**State Clearinghouse No. #2013032004**

# California Department of Water Resources 3500 Industrial Blvd West Sacramento, CA 95691

February 2024

Project Yolo Bypass Salmonid Habitat Restoration and Fish Passage Project

Figure 4. Alternative 1 Transport Channel (Figure 2-4 of the 2019 EIS/EIR)

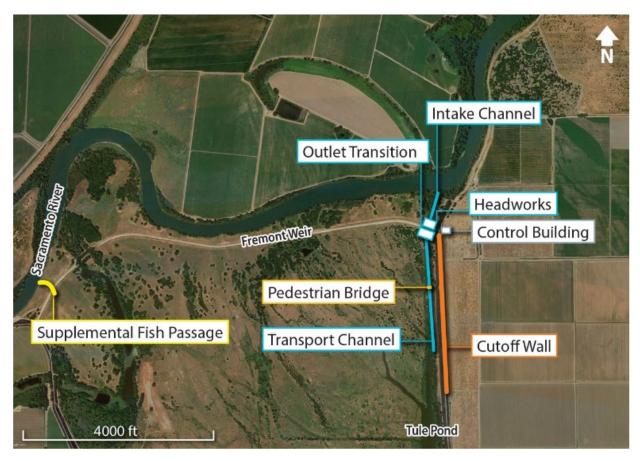
#### 2.2.2 Alternative 1 Transport Channel – Cutoff Wall

As described in the 2019 EIS/EIR Chapter 2, Section 2.4.1.6 and 2.4.1.7, Transport Channel and Seepage Measures, the Project included an excavated channel (referred to as the Transport Channel) to connect the headworks structure to the northern portion of Tule Pond. To address potential impacts to levee seepage and stability near the

channel, a subsurface cutoff wall paralleling the excavation was included in the Project. The cutoff wall was originally planned to be approximately 2,850-feet-long and 30-feet-deep at the toe of the levee. **Figure 4** (Figure 2-4 of the 2019 EIS/EIR, section 2.4) presents the preliminary concept for the Transport Channel improvements and cutoff wall.

Construction of the channel without the cutoff walls would introduce negligible changes on the through seepage criteria, underseepage exit gradient and slope stability factor of safety, as shown in Table 1 and Table 2. The sensitivity analysis result for Cross Section A-A' (Table 1) shows a slight increase in underseepage exit gradient (increase from 0.08 to 0.14) across the blanket layer at the landside levee toe, a slight decrease in landside slope stability factor of safety (reduced from 2.04 to 2.01) and no change in through seepage. This sensitivity run is based on a conservative depiction of a continuous sand deposit into the aquifer layer, which was a condition only encountered in one historical boring and not in any of the recent explorations (DWR 2022). The increase in calculated exit gradient for the sensitivity analysis is very small and remains well below the USACE underseepage criteria (less than 0.5)(DWR 2022). The resulting underseepage exit gradients and factors of safety appeared similar in all other cross sections, with and without the proposed channel excavations, because of the presence of the intact waterside blanket layer beneath the channel bottom. The intact blanket layer at the channel bottom resists seepage flow into the aguifer layer; therefore, Proposed Change 1 would not significantly increase the seepage pressure beneath the blanket layer (DWR 2022). See Addendum Appendix B for a detailed assessment of the seepage and landslide slope stability analyses.

Figure 6. Agricultural Road Crossing 1 Improvements (Figure 2-2 of the 2019 EIS/EIR)

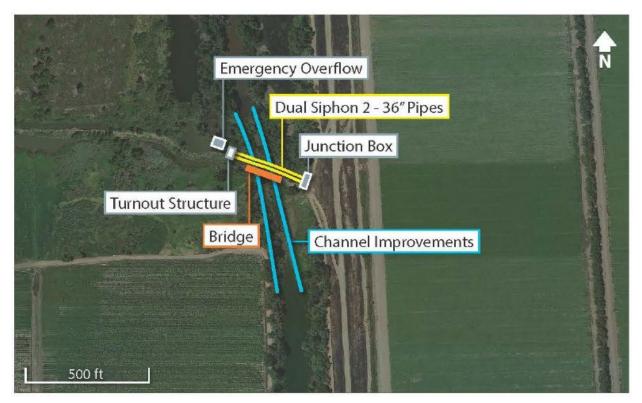
As described in the 2019 EIS/EIR Chapter 2, Section 2.3.1, ARC 1 and Cross-Canal Berms, ARC 1 improvements included construction of a bridge for vehicular traffic over Tule Canal. **Figure 6** (Figure 2-2 of the 2019 EIS/EIR, section 2.3.1) shows the improvements that were proposed at ARC 1; the proposed items included a vehicular bridge, an under-channel siphon with emergency overflow, and channel improvements.

After consulting with the landowner, the under-channel siphon and the bridge were removed from the Project scope. The bridge was deemed unnecessary for access as there is an existing crossing, 0.5 mile south of the proposed vehicle bridge, that would maintain access to and from the Yolo Bypass and the east levee. Removing the ARC 1 vehicle bridge from the Project improves fish passage within Tule Canal by reducing inwater structures that fish must navigate around.

The proposed under-channel siphon element and appurtenances were removed, although the drain which allows for excess water from the landside of the levee into the Yolo Bypass would remain in place and any additional effects to the conveyance of water at this location would be addressed directly with the landowner. This change would not otherwise affect water rights along with existing contracts and agreements along Sacramento rivers and within the Yolo Bypass.
